DEVIATION REQUEST AND DECISION FORM

Project Name : Sterling Ranch East Community Center Parkland Area Phase 1
Schedule No.(s) : 5233410022
Legal Description : TR. B STERLING RANCH EAST FIL. NO. 1

Part 1: Access to a Collector Street: A deviation from the standards of or in Sections 2.2.5.D and 2.3.2 (Table 2-7) of the Engineering Criteria Manual (ECM) is requested. Requests for access are reviewed by the ECM Administrator as per ECM Section 2.2.4.B.4. The request is for the following access point to Sterling Ranch Road, an Urban Non-Residential Collector Street: A full-movement access point is proposed to the west (north) side of Sterling Ranch Road located approximately 340 feet southeast of Laguna Niguel Way. The access will provide access to the regional park site.

Deviation Exhibit No. 1

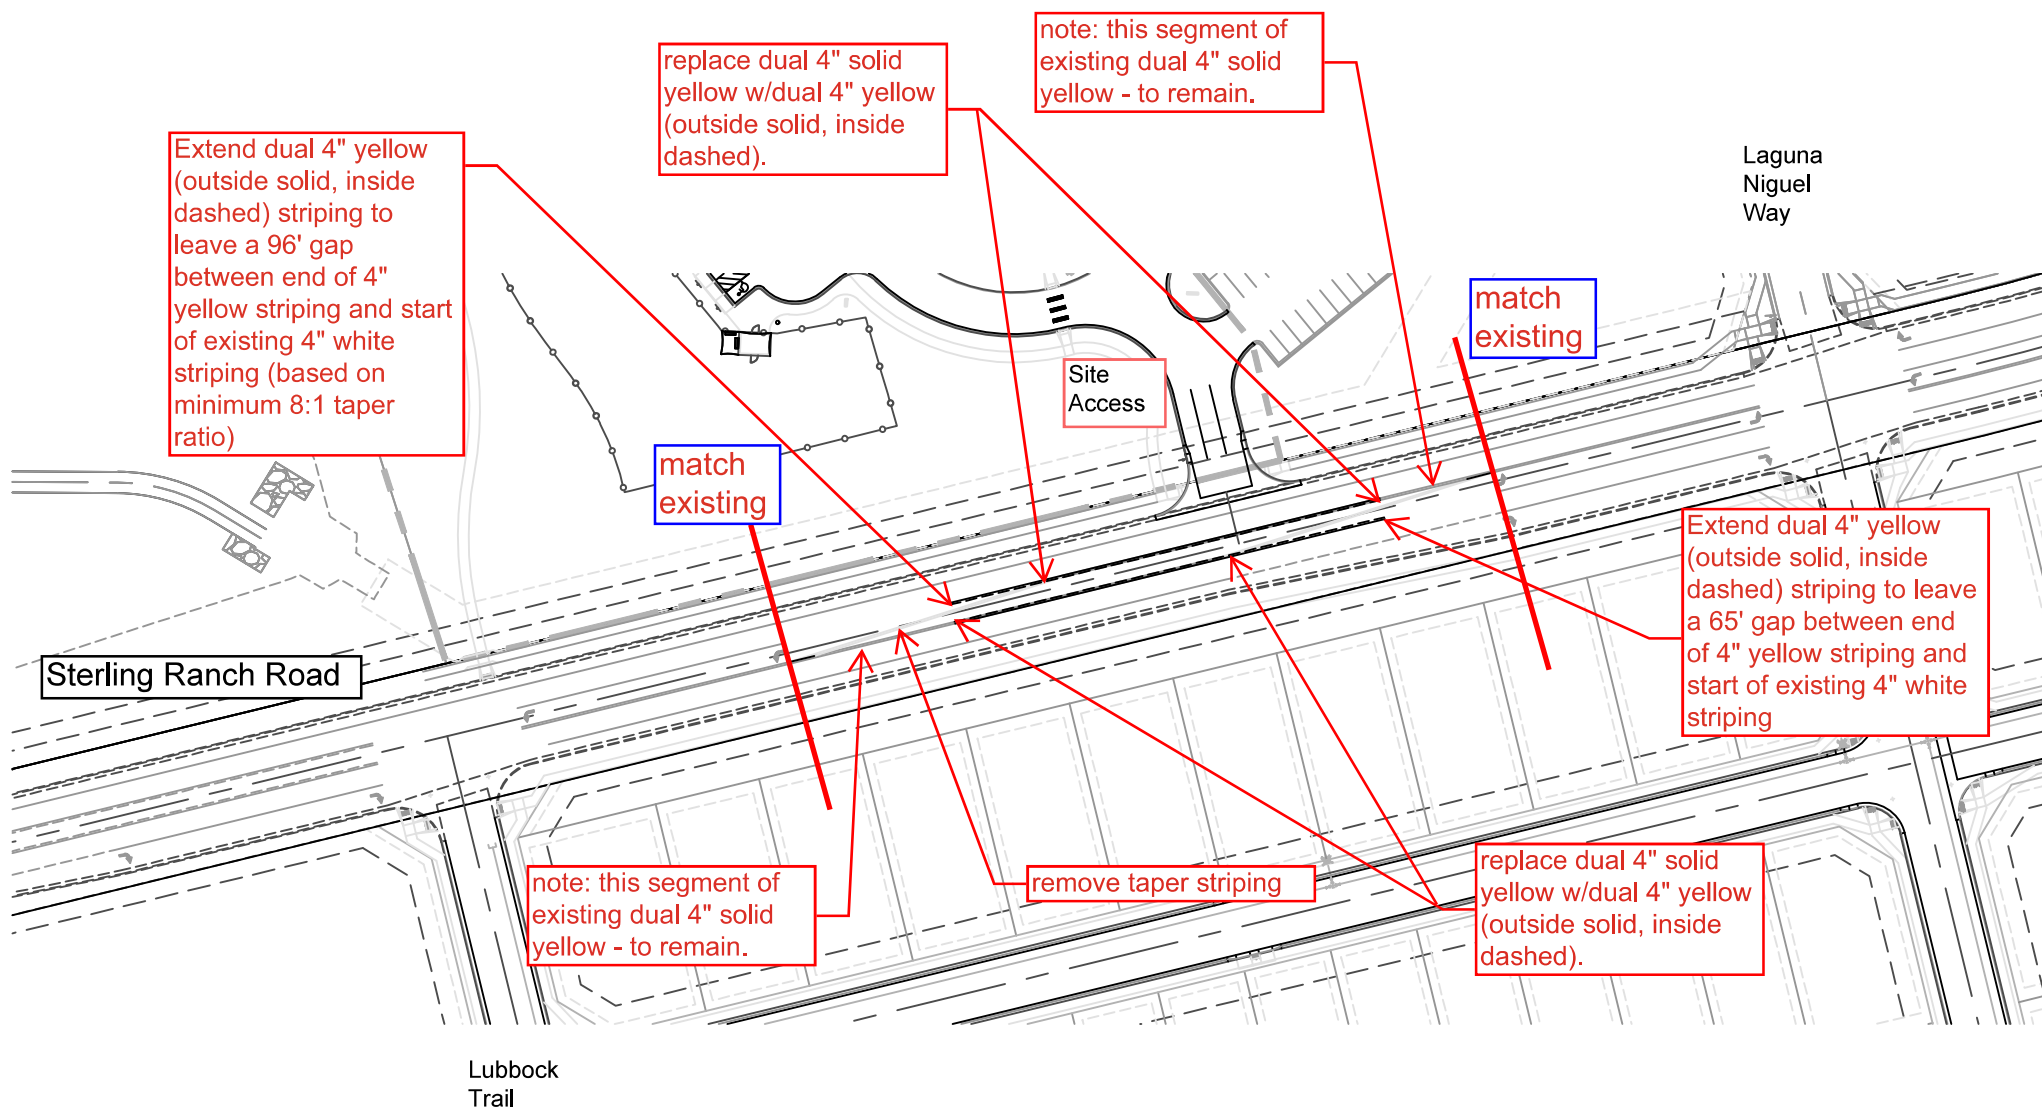
Part 2: Turn Bay Lengths: A deviation from the standards of or in Section 2.3.7.D.1 of the Engineering Criteria Manual (ECM) is requested. The request is for modification to the existing striping/markings to incorporate center, two-way left-turn lane (TWLTL) striping across the proposed park access. The left turn lane (including 8" white lane line and arrow pavement markings) would remain unchanged. The transition taper for the left-turn lane at Laguna Niguel Way would be modified to accommodate the change which allow for 1) a striping-gap-type lane-transition taper (of 65') (this type of taper is common with TWLTL configurations) in lieu of the ECM standard 96' reverse-curve bay taper (8:1 taper ratio) and 2) vehicle storage within the ECM-standard lane length (rather than decel plus storage).

Please refer to **Deviation Exhibit 1** for design details. The proposed alternative is for modification to the existing striping/markings to include a change to TWLTL striping across the access. Also, the left-turn taper at Laguna Niguel Way would be modified to accommodate the change which allow for 1) a striping-gap-type lane transition taper of 65' (this type of taper is common with TWLTL configurations in leu of the ECM-standard straight or bay-type tapers. Although this deviation would not necessitate a change to the **existing** (as-striped) left-turn lane as defined by the current 8" white lane line and arrow pavement markings, this deviation would also, 2) "memorialize" the current condition of vehicle storage within the ECM-standard lane length (rather than decel. plus storage).

The proposed left-turn lane would have abbreviated lane and taper lengths. The ECM standard is 155-foot lane plus 50-foot minimum storage (the **ECM** requires 50' minimum storage for any turn lane), plus 160-foot taper (or 96' bay taper - ECM Table 2-26 allows for a taper ratio of 8:1 for tangent bay tapers in constrained locations. Based on a lane width of 12- feet, the 8:1 ratio would result in a 96-foot tangent-bay taper). The proposed 65-foot-long gap-type taper would be about 30 feet short of the ECM standard.

Also, the left-turn taper at Laguna Niguel Way would be modified to accommodate the change to a striping-gap-type lane transition taper (of 65') (this type of taper is common with TWLTL configurations) in lieu of the ECM-standard 96' reverse curve bay taper (8:1 taper ratio).

The 65' gap/taper is a recommended site-specific length to allow the TWLTL striping to extend 30' additional feet past the PC at the access (verses terminating the TWLTL striping at the start of a 96-foot taper for the left-turn lane at Laguna Niguel Way).

The ECM standard is 155-foot lane plus 160-foot taper, plus storage. Please refer to the attached Deviation Exhibit.

The proposed design incorporates a change to TWLTL striping across the access. Given the spacing to Laguna Niguel Way, the left-turn taper at Laguna Niguel Way would be modified to accommodate the change which allow for 1) a striping-gap-type lane transition taper (of 65') (this type of taper is common with TWLTL configurations) in leu of the ECM standard 96' reverse curve bay taper (8:1 taper ratio) and 2) the lane to remain as currently striped. This deviation would not necessitate a change to the **existing** (as-striped) left-turn lane as defined by the current 8" white lane line and arrow pavement markings. This deviation would "memorialize" the current condition of vehicle storage within the ECM-standard lane length (rather than decel. plus storage).

Deviation Exhibit 1 (attached) graphically summarizes the proposed striping/marketing modifications and the detailed elements of the deviation request. The projected queue lengths are a maximum of 31 feet approaching both the proposed site access and Laguna Niguel Way. Please refer to the attached queuing analysis reports for complete details.

This request has been determined to have met the criteria for approval. A deviation from Section 2.2.5.D & 2.3.2 of the ECM is hereby granted based on the justification provided.
